APPLICATION NO.	FILING DATE	FIRST NAMED INVENTOR	ATTORNEY DOCKET NO.	CONFIRMATION NO.	
10/673,155	09/30/2003	Kazuyuki Ichikawa	243317US3	9792	
22850	7590 09/02/2005		EXAMINER		
OBLON, SPIVAK, MCCLELLAND, MAIER & NEUSTADT, P.C. 1940 DUKE STREET			BINDA, GREGORY JOHN		
	RIA, VA 22314		ART UNIT	PAPER NUMBER	
	·		3679

Advisory Action Before the Filing of an Appeal Brief

OBLON, SPIVAK, et al Docket No: 243317US3 Inventor: Kazuyuki ICHIKAWA, et al. Serial No: 10/673,155 Reply to OA dated: May 16, 2005 Replacement Sheet

F I G. 1

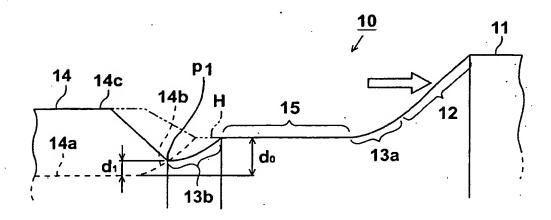
13. \(\substitute \) Other: A substitute specification is still needed. It is the	only way to correct the directional	errors made by applic	ant in the
amendment filed April 19, 2005. The replacement drawings file objection noted in item 3a of the final rejection. Applicant's rem	narks not withstanding, the imagina	d because they fail to iry portion of the line	correct the 14b is not drawn
any differently in the replacement drawings than it was drawn in	n the previously filed drawings.	12	
		Greg Binda

Disproved 8-29-05

F I G. 2

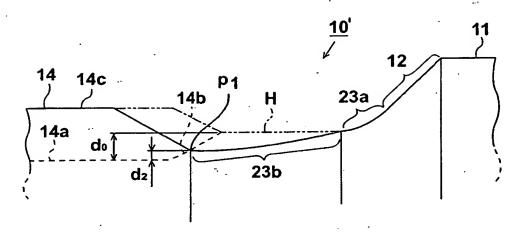
Dis approved
8,29.05

F I G. 4

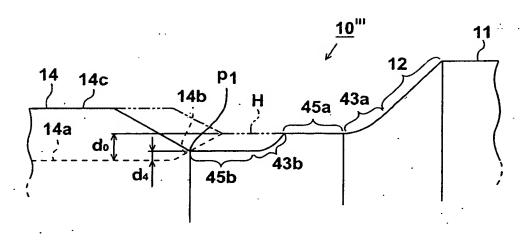
D. 29.05
